**FORMER JOHN LEWIS DEPOT, LETCOMBE STREET, READING
(ALSO KNOWN AS JLP MILL LANE)**

**LANDSCAPE DESIGN ADDENDUM
SEPTEMBER 2025**

Document reference number: SY743-R-0002 Landscape Design Addendum Sept 2025

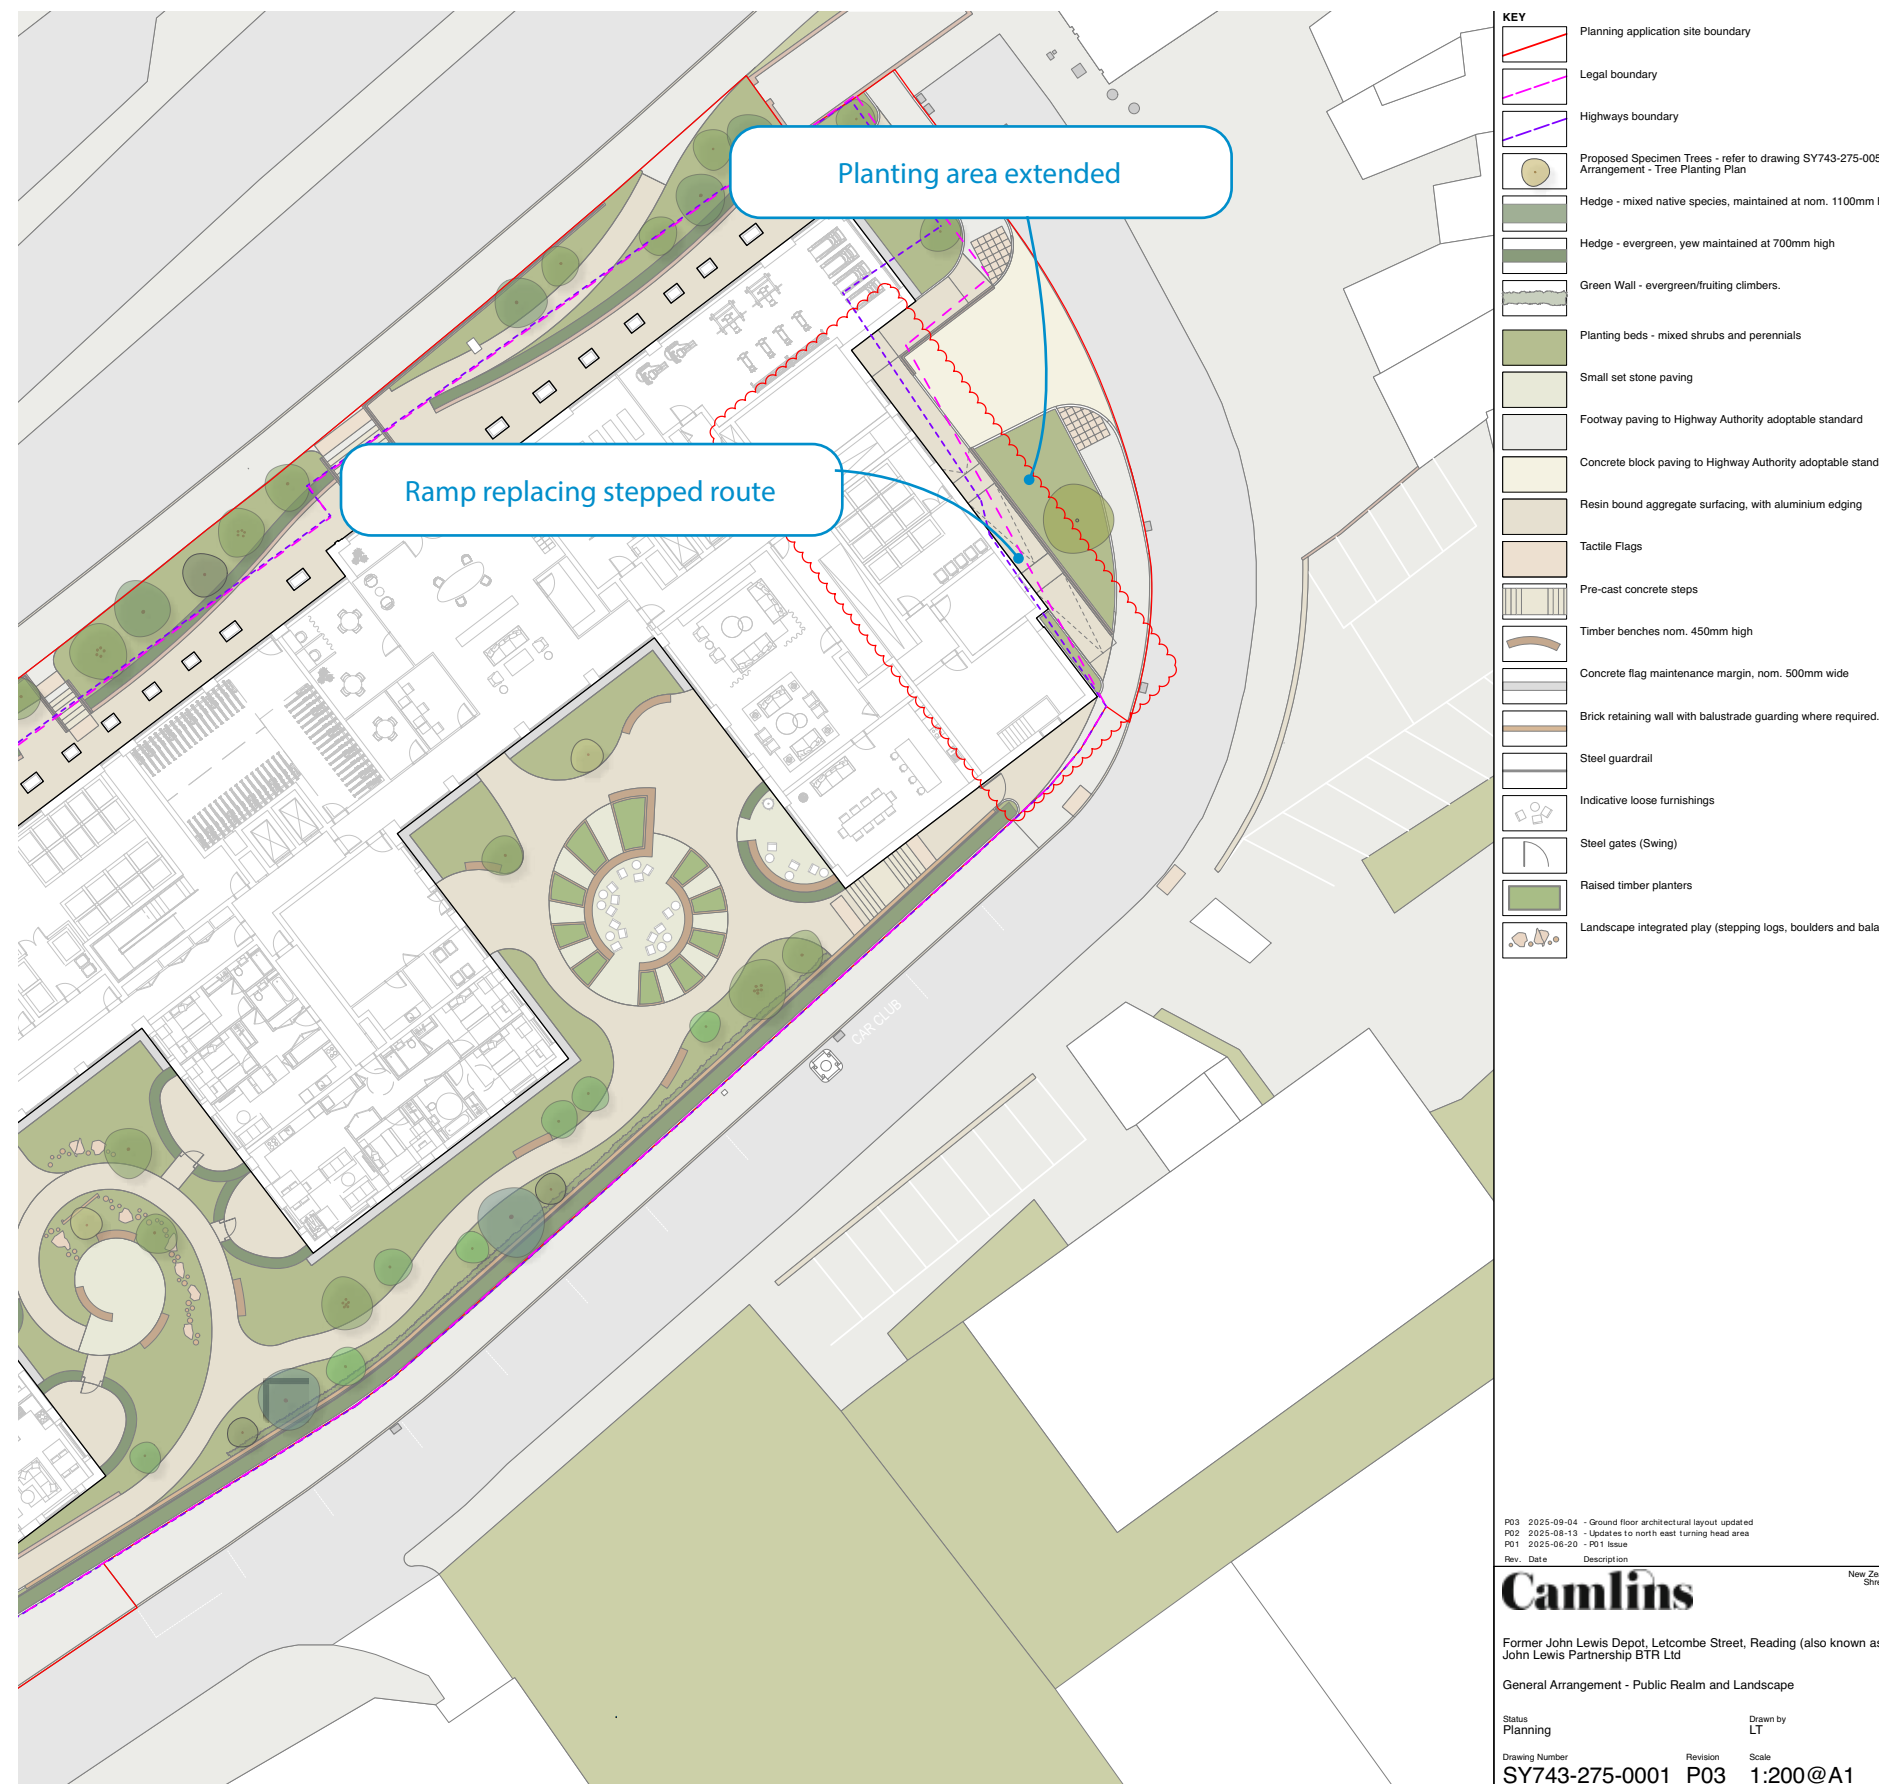
- A ramped pedestrian route adjacent to the eastern elevation of the building in place of the stepped route shown previously.
- The turning head at the eastern end of Crossland Road has been reduced and the adjacent soft landscaping area has increased
- The uncontrolled pedestrian crossing on Crossland Road has also been removed.

General Arrangement - Landscape Levels			
Status	Drawn by	Checked by	
Planning	LT	PSS	
Drawing Number	Revision	Scale	Date
SY743-275-0011	P03	1:200@A1	20.06.2025

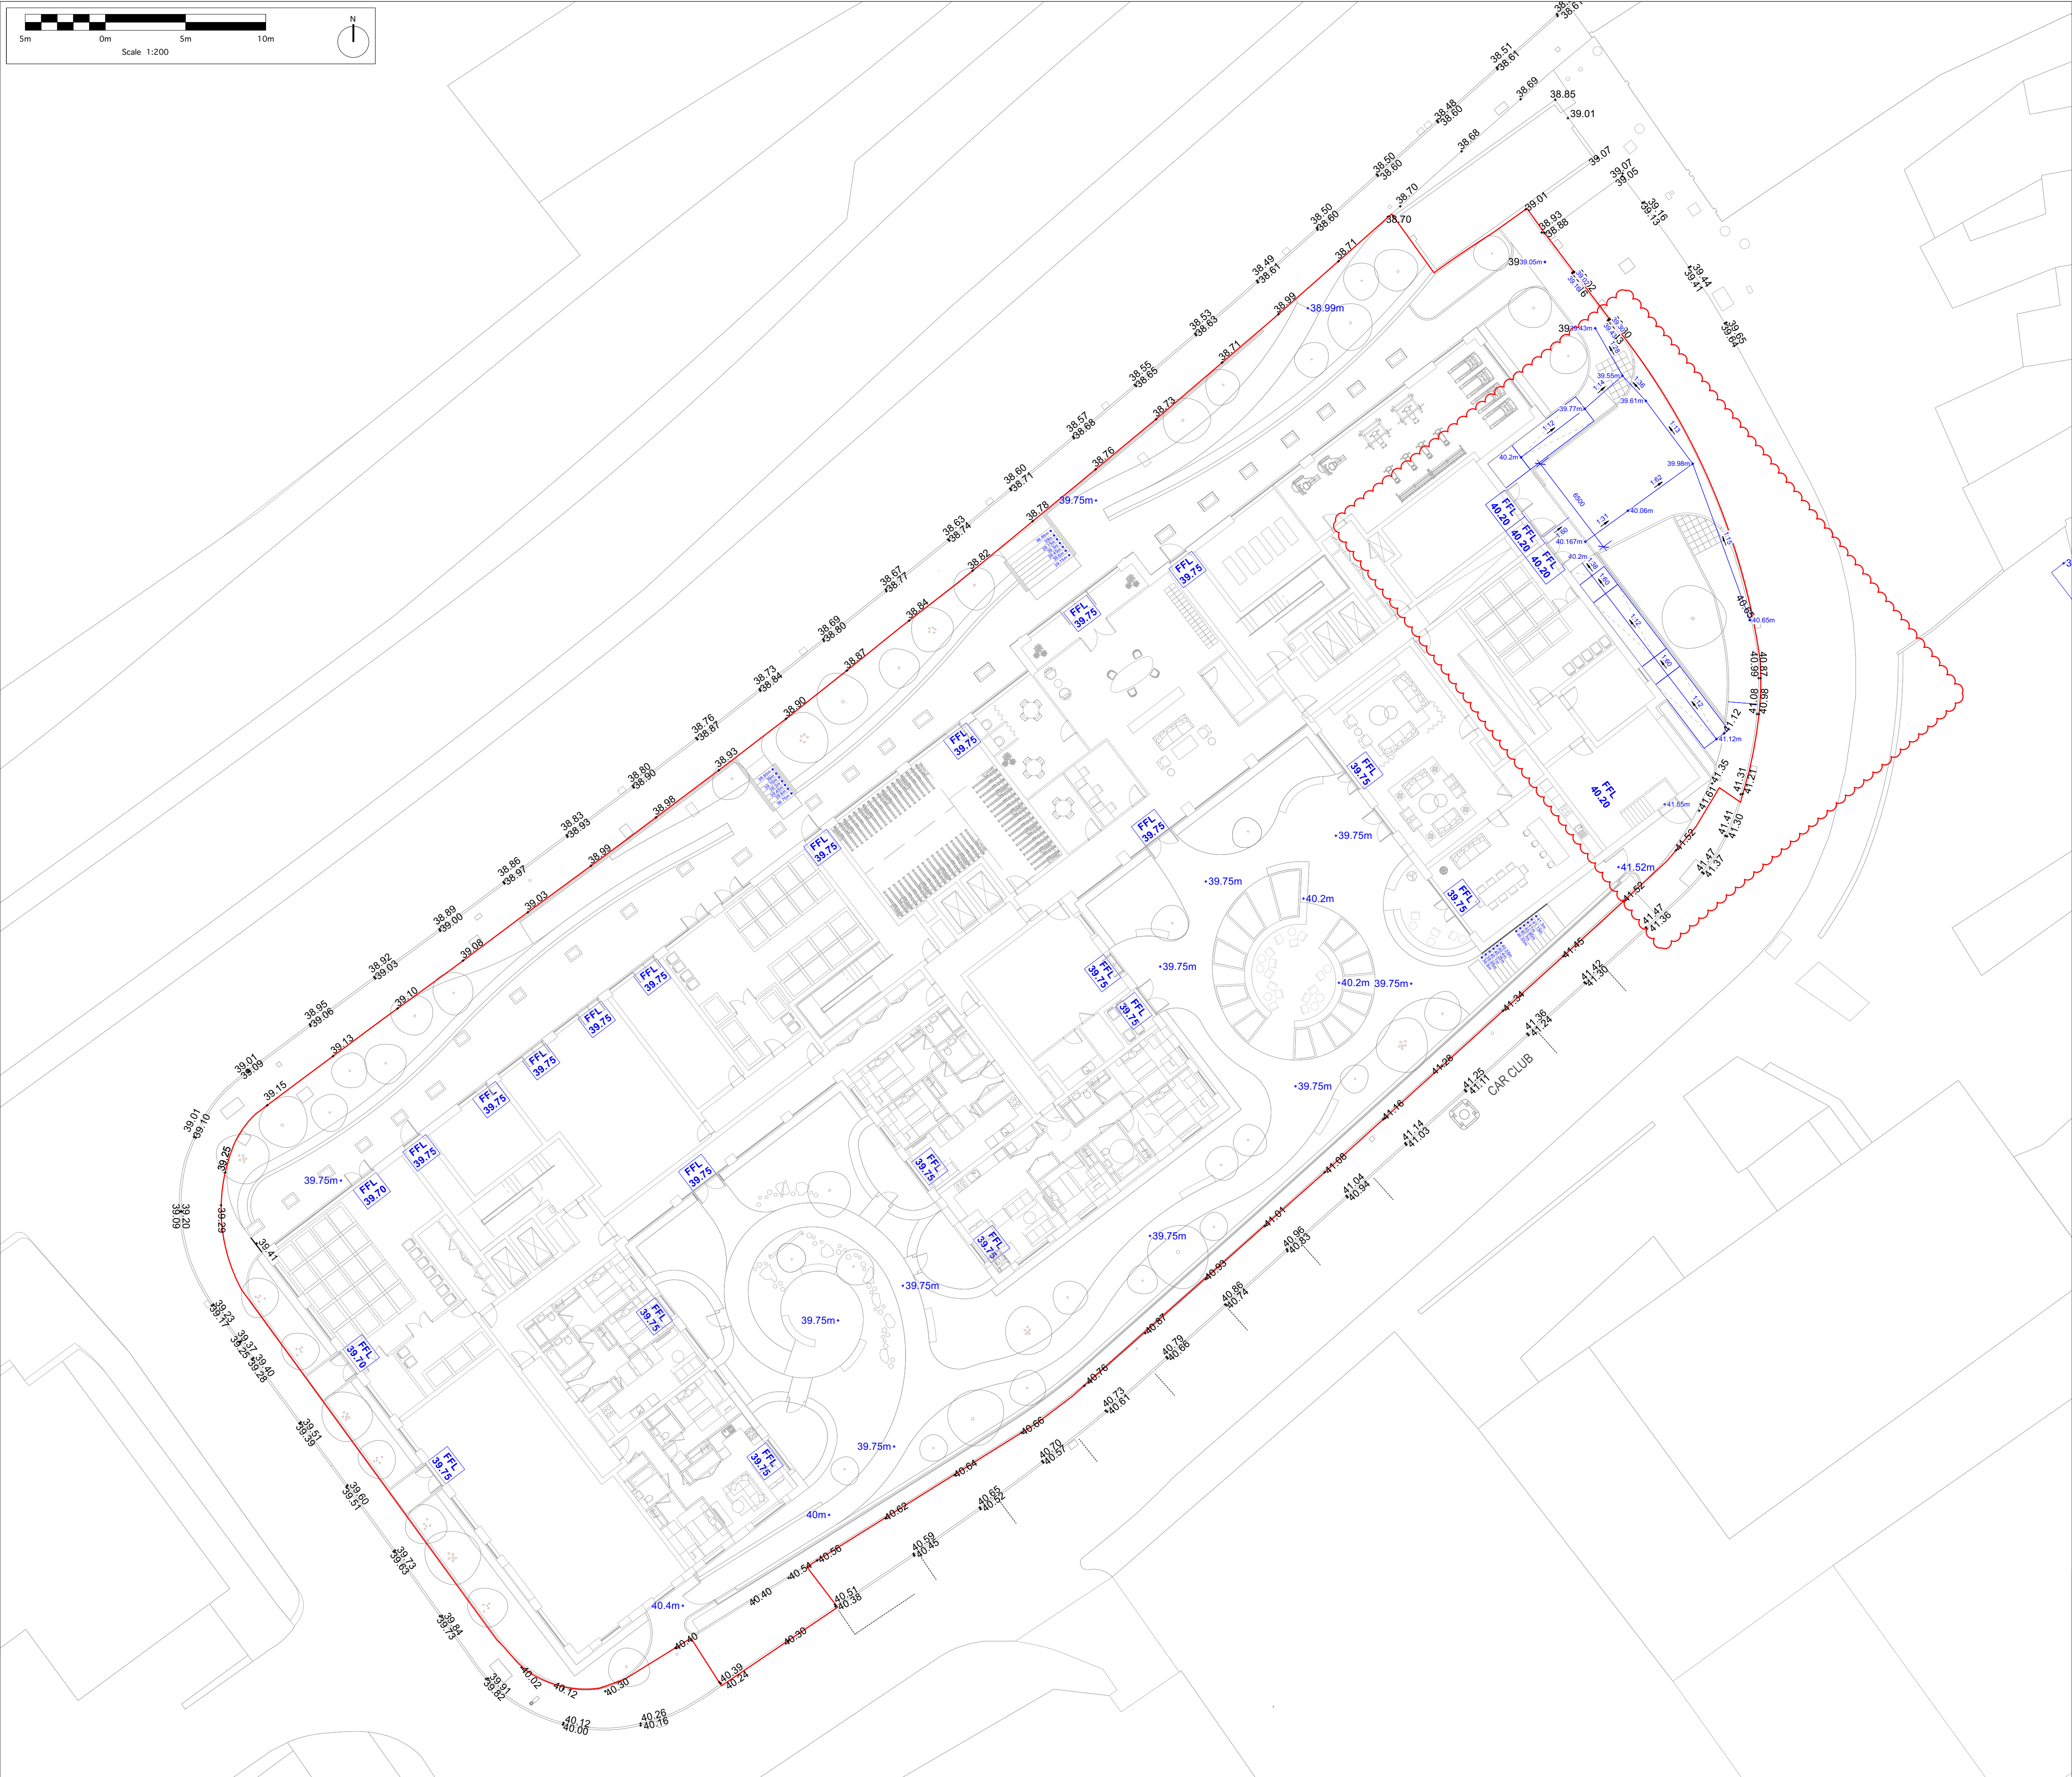
P03	2025-09-04	- Ground floor plan updated, levels modified to accommodate.	KS	JS
P02	2025-08-13	- Updates to north east turning head area	LT	PSS
P01	2025-06-20	- P01 Issue	LT	PSS
Rev.	Date	Description	Revised by	Checked by

General Arrangement - Areas of Hard Surfaces

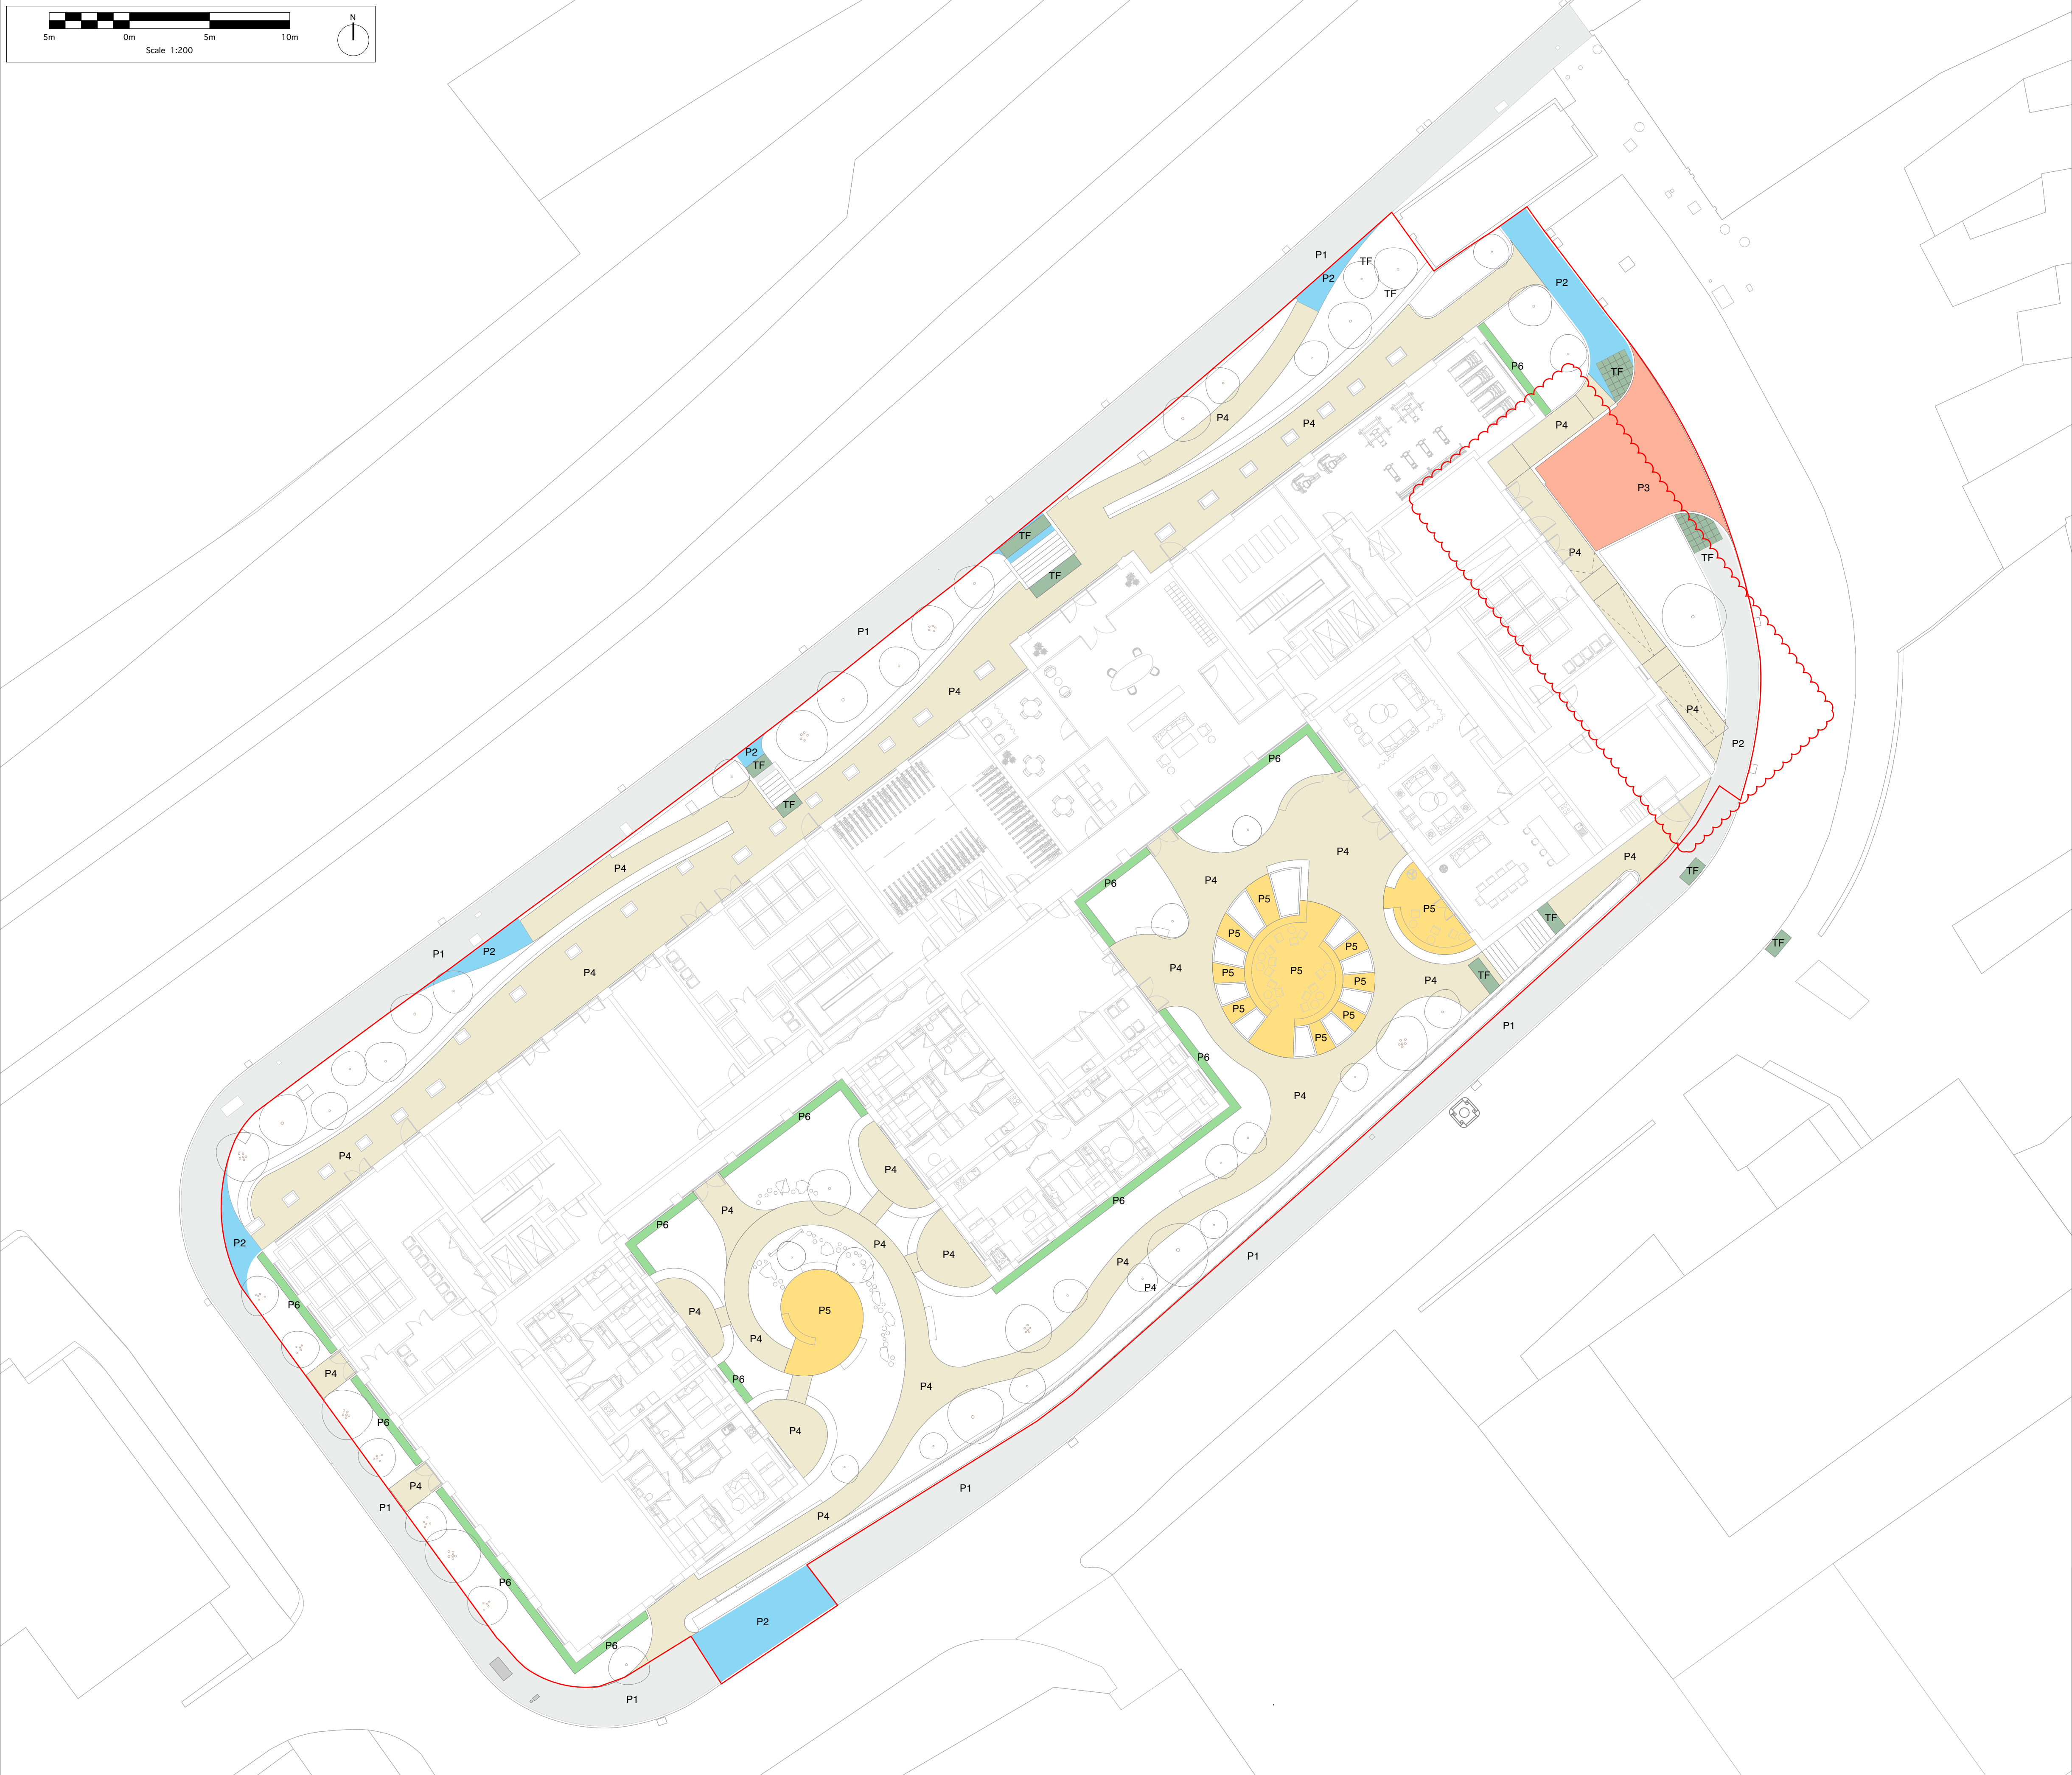
P02	2025-09-10	Ground floor plan updated - steps replaced by ramped route	KS	MSS
P01	2025-06-13	- P01 Issue	LT	PSS
Rev.	Date	Description	Revised by Checked by	
			New Zealand House, Abbey Foregate, Shrewsbury, Shropshire, SY2 6RD 01743 590 779 www.camlins.com
